From: Marcus Fylan-Smith [REDACTED]
Sent: 19 August 2024 16:57
To: Paul Marino
Cc: [REDACTED]
Subject: 21185 Carn Thomas - Response to drainage comments
Attachments: Surface Water Drainage Porthmellon Carn Thomas Hill.png; 21185 Infodrainage Rev.C.pdf; 21185 Civils Transmittal 19.08.24.pdf; 21185-200P2.pdf; 21185 Flood Risk Assessment Rev.A.pdf

Please see below responses to the drainage queries. Many of them remain the same as before the meeting because we've not had contact with the SuDs representative regarding the original responses.

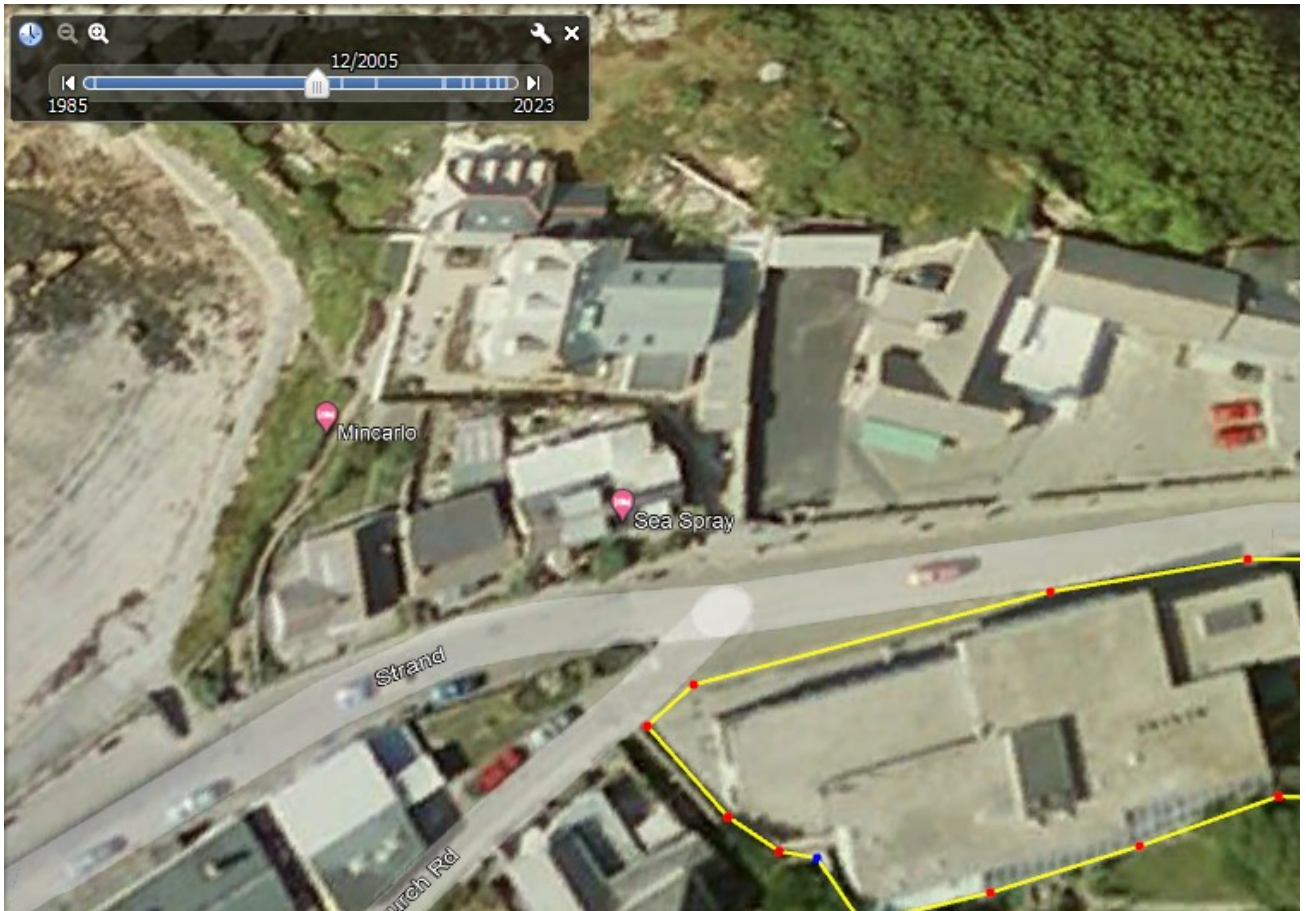
- *In the report, it mentions that there is a requirement to design a SuDS solution for up to the 1 in 100-year flood event plus 50% climate change plus an additional 10% on the impermeable area for future development and this has not been provided.*

Yes it has. Please refer to FRA. We also attach again a copy of InfoDrainage calculations.
